Our Ref: J11894

Re: 36 Redington Road, London NW3

Further to the audit report produced by Campbell Reith dated September 2015 (ref 12066-41 Rev D1), in relation to the BIA submitted as part of the planning application for the above address.

SITE; 36 REDINGTON ROAD, ADDENDUM TO REPORT J11894

Figure CU2 - Line Displacement (Long Term)

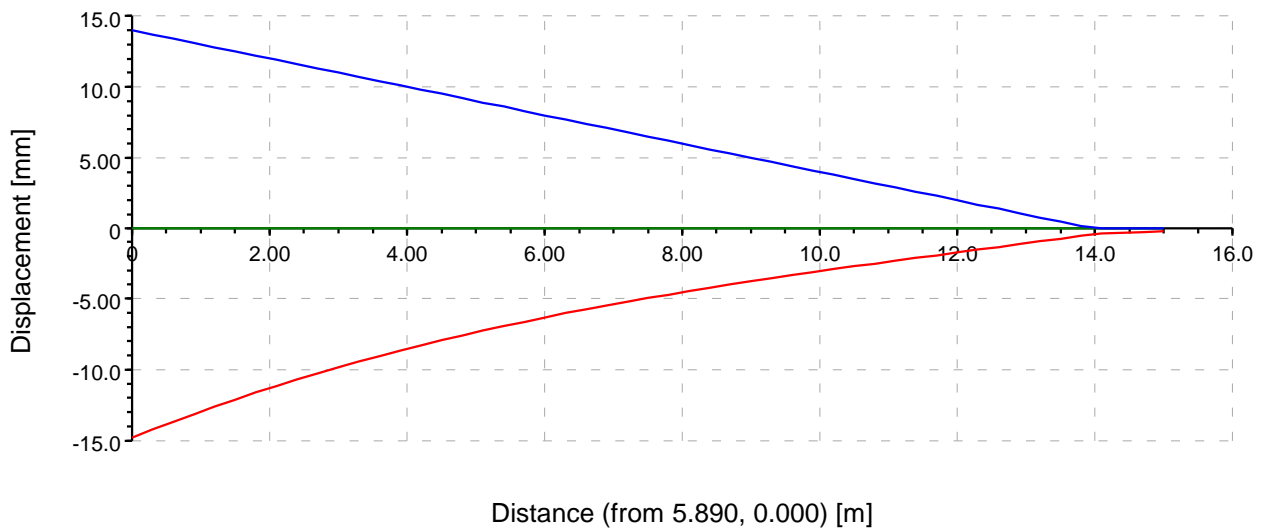
In the case of the nearby highway, a combined plot of horizontal and vertical movements associated with pile installation and bulk excavation are given in Figure CU1 and for the long-term drained condition Figure CU2. The Highway Department should be consulted in relation to the predicted movements. Again if the movements are considered unacceptable the use of propping measures may need to be considered. Given the magnitude of these predictions at the very least remedial works to the footway would be anticipated.
